Service Letter No. 310

SUBJECT: Locking of Landing Gear Motor Release Arm

MODELS AFFECTED: PA-24 and PA-24 "250"  
Serial Numbers 24-1 to 24-504 inclusive

GEAR MOTOR RELEASE HANDLE STRAP INSTALLATION	
SERVICE LETTER	NUMBER 310
PIPER AIRCRAFT CORPORATION	
LOCK HAVEN, PENNSYLVANIA

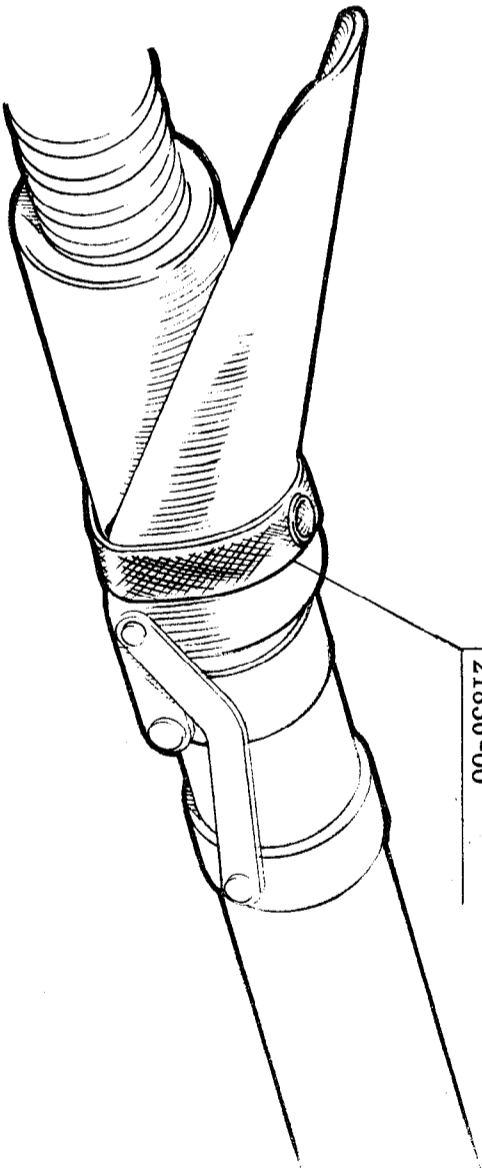
The safety wire used to hold the landing gear retraction motor release arm in a closed position shall be replaced on the above mentioned airplanes by an elastic strap, part number 21836-00, per sketch on the reverse side of this letter.

ELASTIC STRAP  
21836-00
